change notice	date	drawn	checked	approved	title
MD17-PRD-12 V02 to MD17-PRD-12 V03	120216	Ryser Daniel			EF518 XJ Office Blockdiagram Overview size A3 drawingnumber EF518 BL_0000 V00.SCHDOC Revision 120216
Delete Eeprom on Rotary PCB	111104	Ryser Daniel			
change blockdiagram title to EF518 XJ Office	110526	Foltrauer Heinz

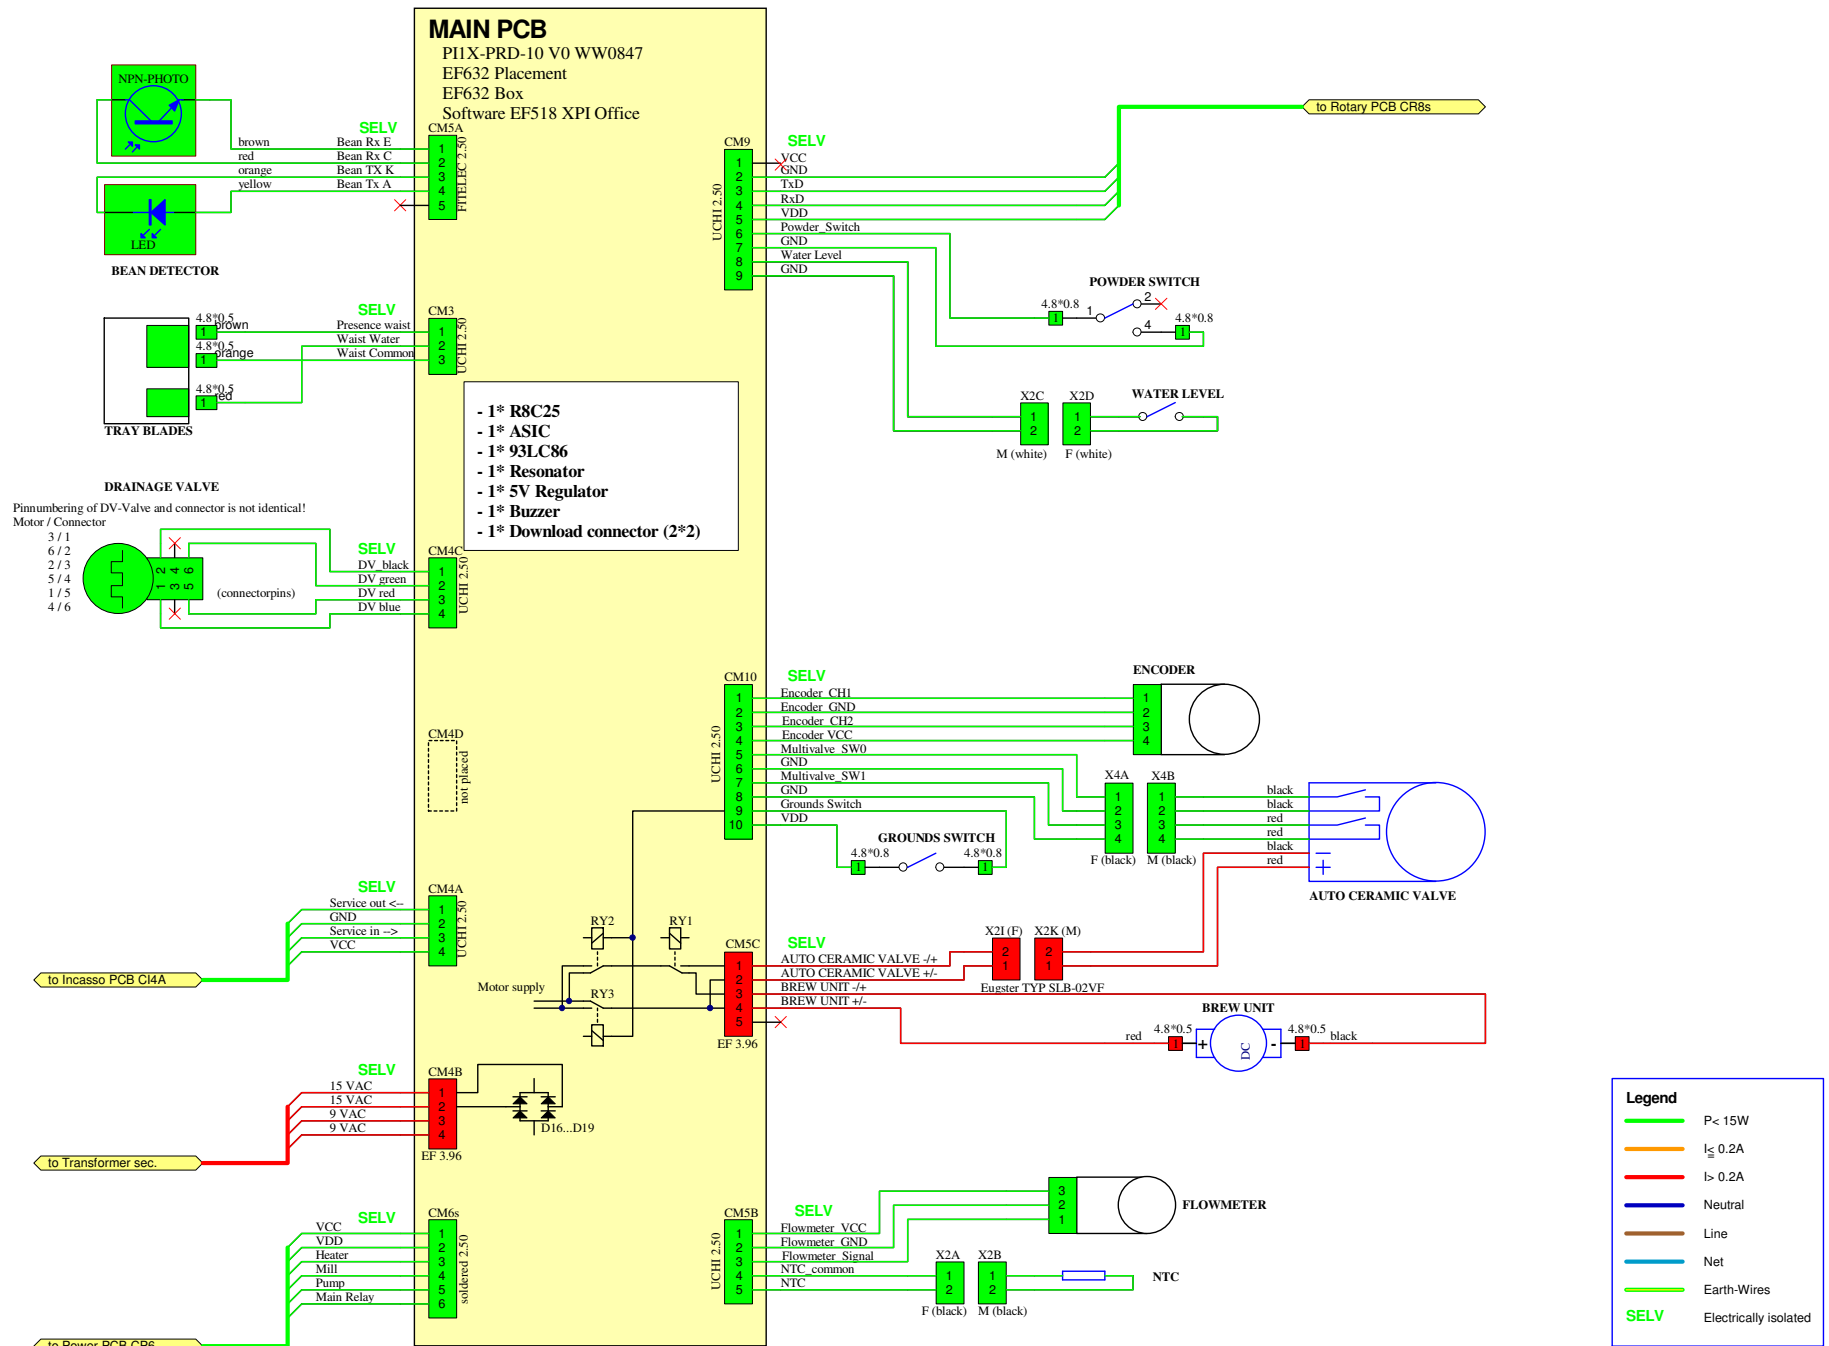
change notice	date	drawn	checked	approved	title
4 Delete UWK-Inductors for Brew Unit	111202	Ryser Daniel			EF518 XJ Office Blockdiagram Main size A3 drawingnumber EF518 BL_0001 V00.SCHDOC Revision 111202
change blockdiagram title to EF518 XJ Office	110526	Foltrauer Heinz			
Delete Pinchvalve Stepper - not used in EF518 XPI Office; Correct placement and box to EF632	110223	Ryser Daniel

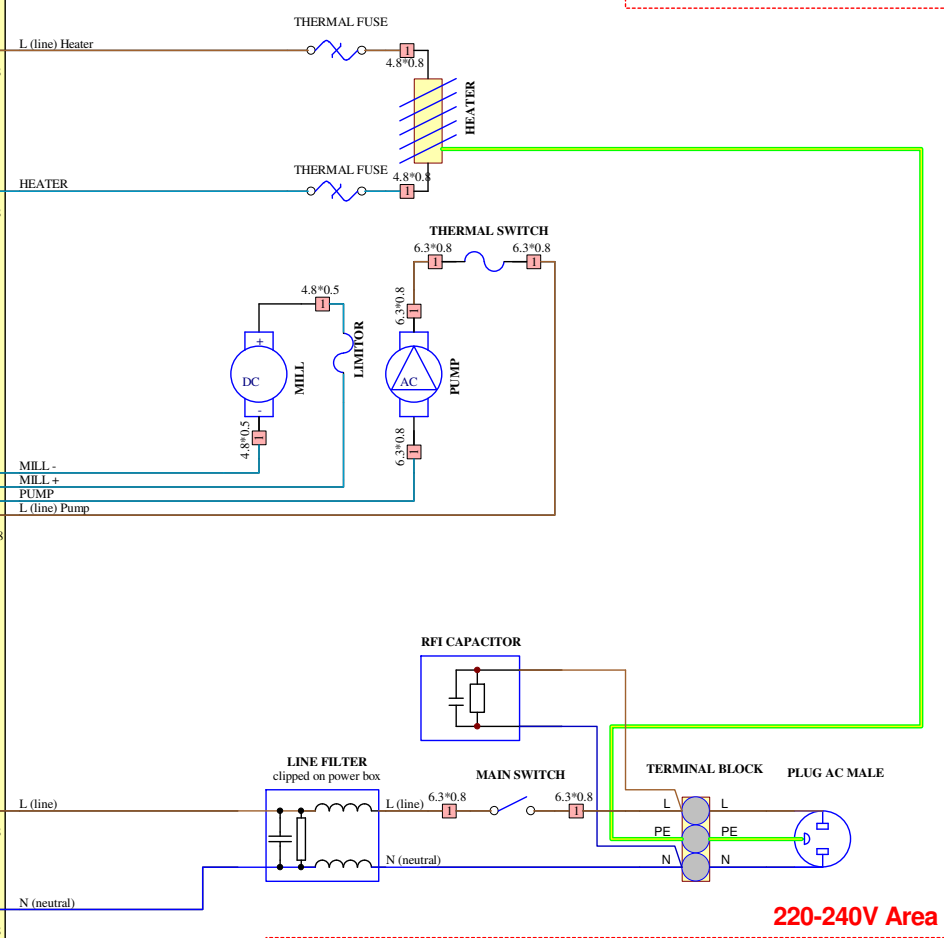
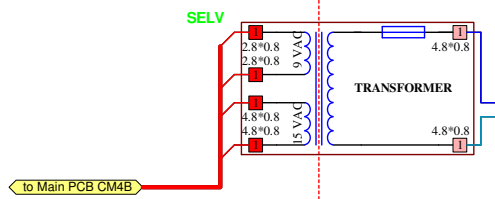
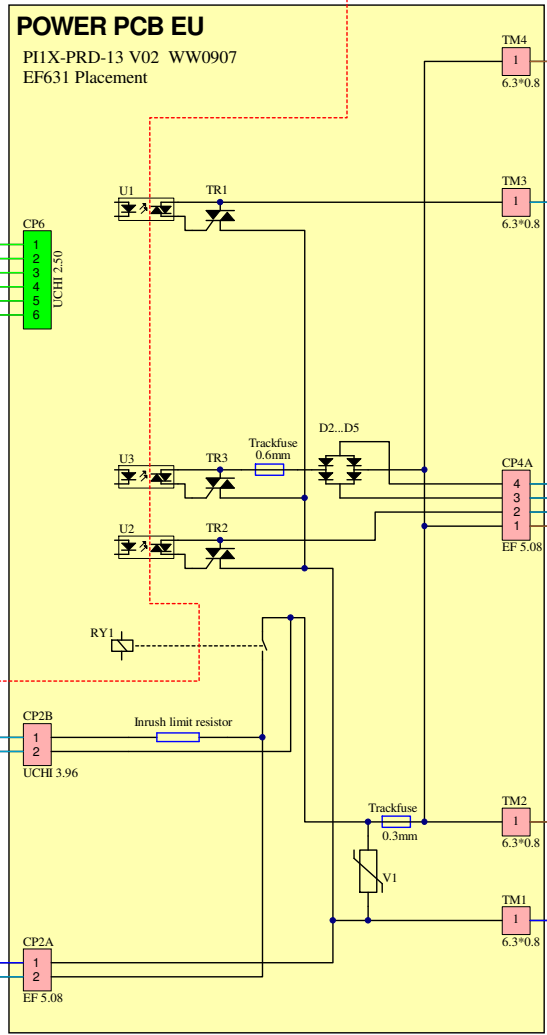
change notice	date	drawn	checked	approved	title
Integrate RFI-Capacitor	120125	Ryser Daniel			EF518 XJ Office Blockdiagram Power 220-240V 50/60Hz size A3 drawingnumber EF518 BLA0001 V00.SCHDOC Revision 120125
Delete UKW-Inductors for Mill	111202	Ryser Daniel			
change blockdiagram title to EF518 XJ Office	110526	Ryser Daniel
